DATE 6/97
Amended 1/98

TECHNICAL BULLETIN

Insufficient AIR Flow – AIR Pump (AIRP) – Diagnosis

MODEL 1995-97 MY
Sedan (4.0L) Range
VIN
720001-779500

ILLUSTRATION 1

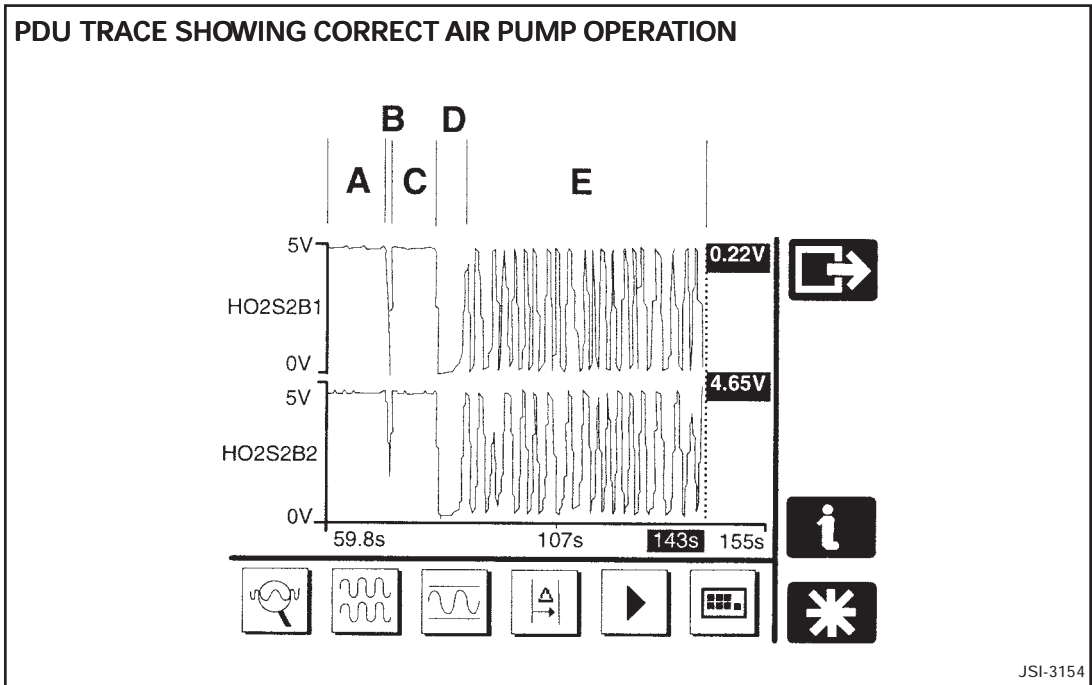
- Zone 'A' shows the initial operation of the air pump (air flow causes lean reading).
- Zone 'B' shows the pump switched off, prior to the diagnostic test (stopping air flow causes rich reading).
- Zone 'C' shows the pump operating during the diagnostic test cycle.
- Zone 'D' shows the pump switched off when the test is complete.
- Zone 'E' shows the lambda voltage switching under normal lambda operation.

ILLUSTRATION 2

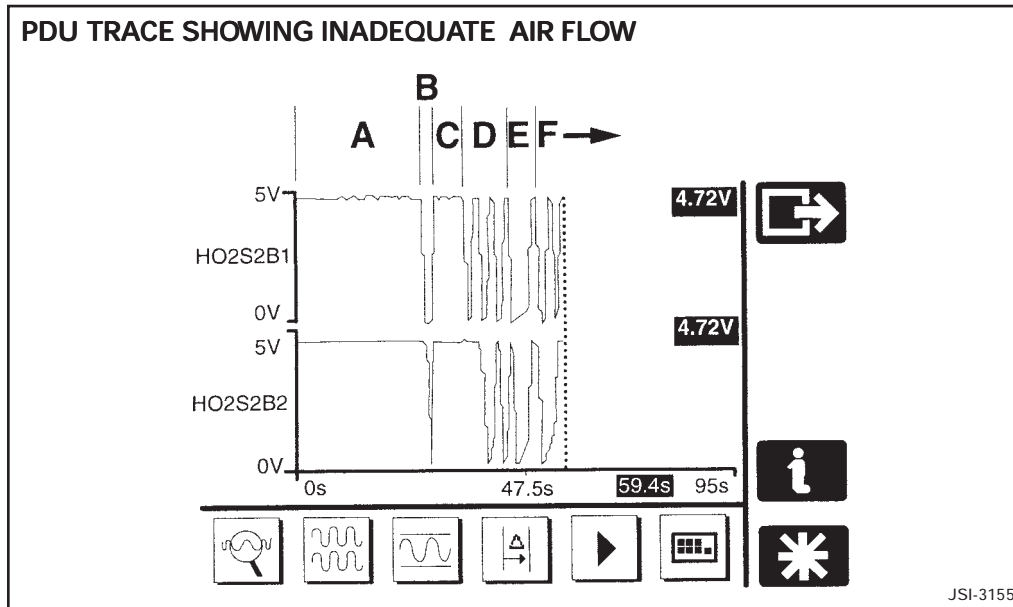
Illustration 2 shows a PDU trace where there is inadequate air flow from the air pump.

Zone 'A' shows the initial operation of the air pump (air flow causes lean reading).

Zone 'B' shows the pump switched off, prior to the diagnostic test (stopping air flow causes rich reading).

Zone 'C' shows the pump operating during the diagnostic test cycle.

Zone 'D' shows the lambda voltage switching to normal feedback, as there is insufficient air flow to sustain the voltage at 5v.

Zone 'E' shows the air pump switched off at the end of the diagnostic cycle.

Zone 'F' shows the lambda voltage switching under normal lambda operation.

DIAGNOSTIC FLOWCHART

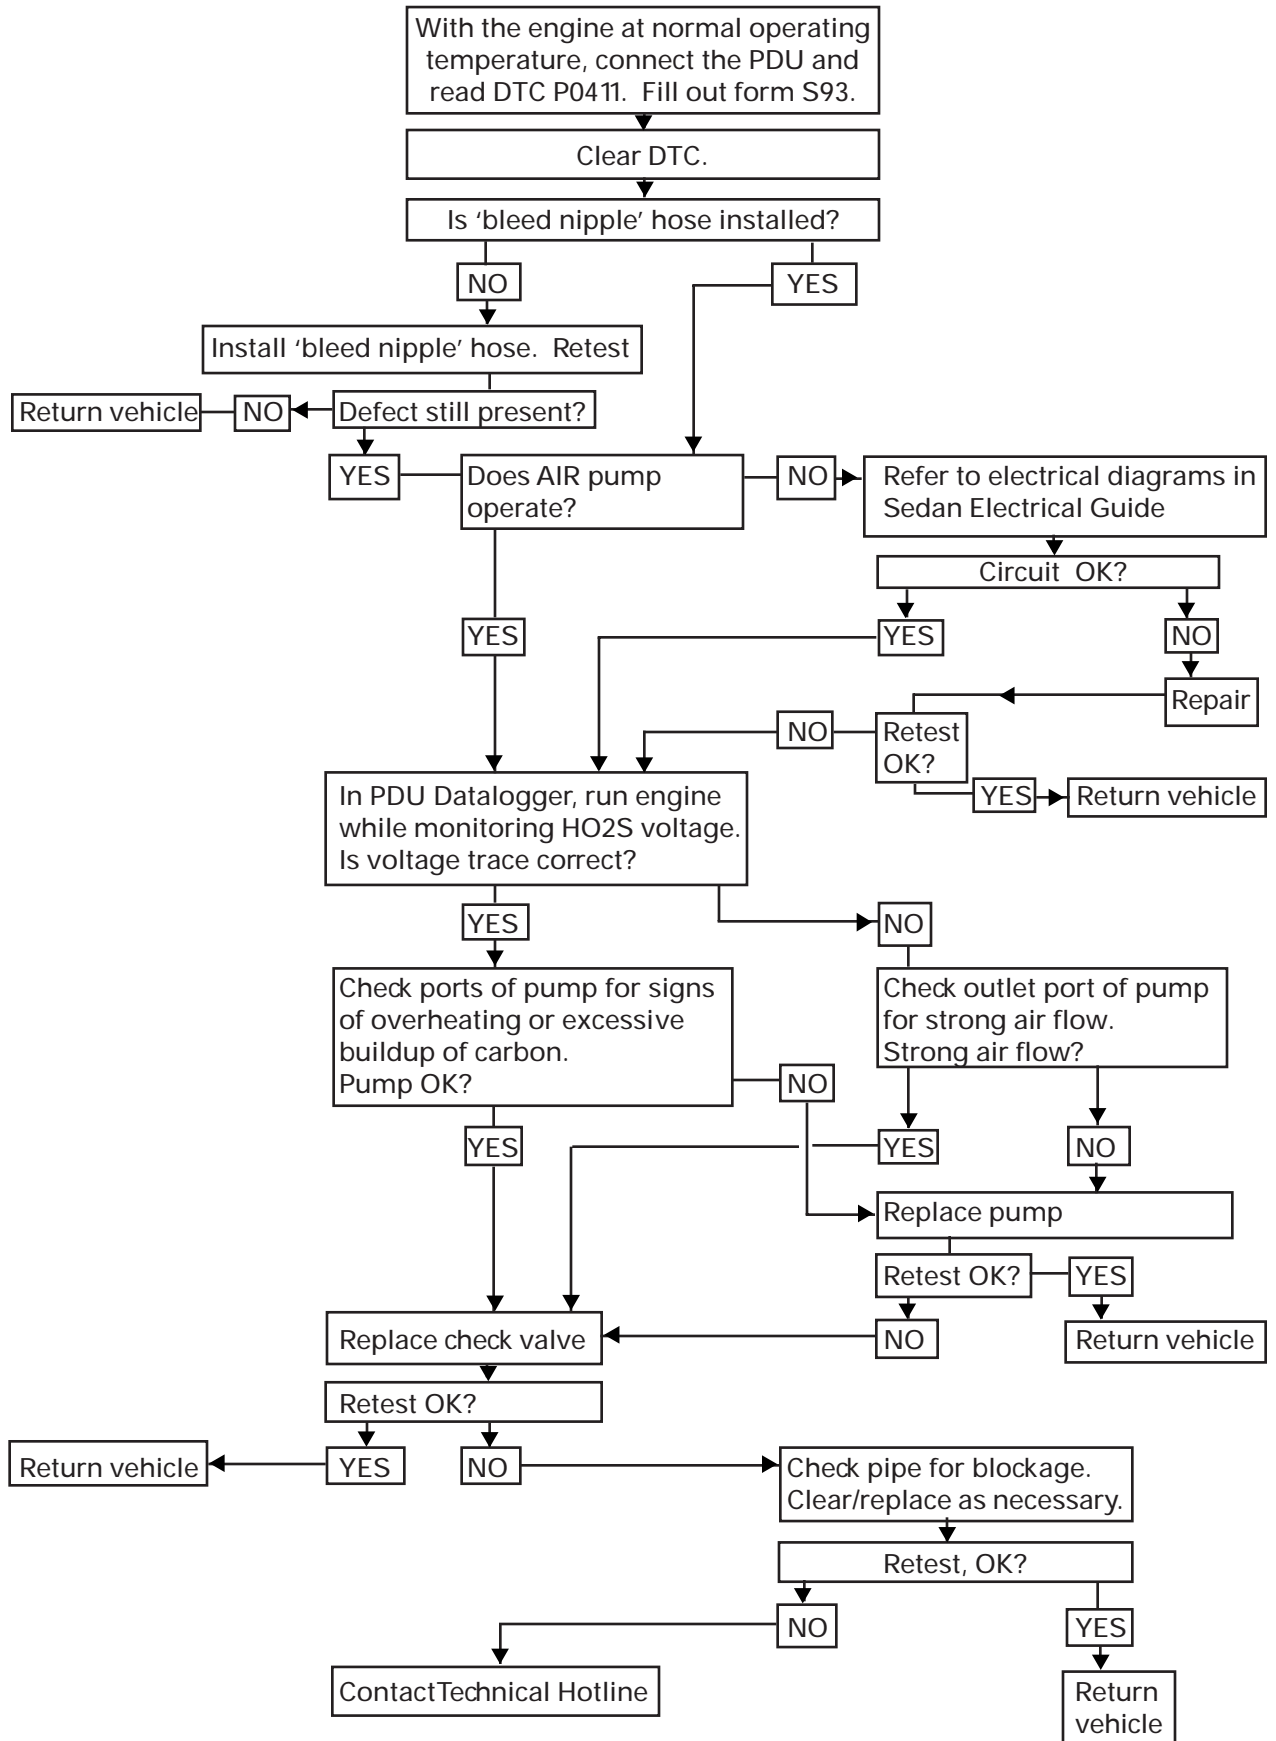
In case of a customer complaint on a Sedan Range vehicle within the above VIN range of MIL illumination, with DTC P0411 flagged, follow the diagnostic flowchart located on the last page of this bulletin. The following text provides additional information.

The statements in boxes correspond to boxes in the flow chart.

The AIR pump operates for a short period of time following every engine start. It typically operates for approximately 10-20 seconds at normal operating temperatures, then switches off for approximately 5-10 seconds, and then restarts to allow the system diagnostic check to occur. This check also takes approximately 5-10 seconds. See Illustration 1, sample of PDU trace. This complete cycle takes place each time the engine is started. **This is the re-test referred to in the flow chart.**
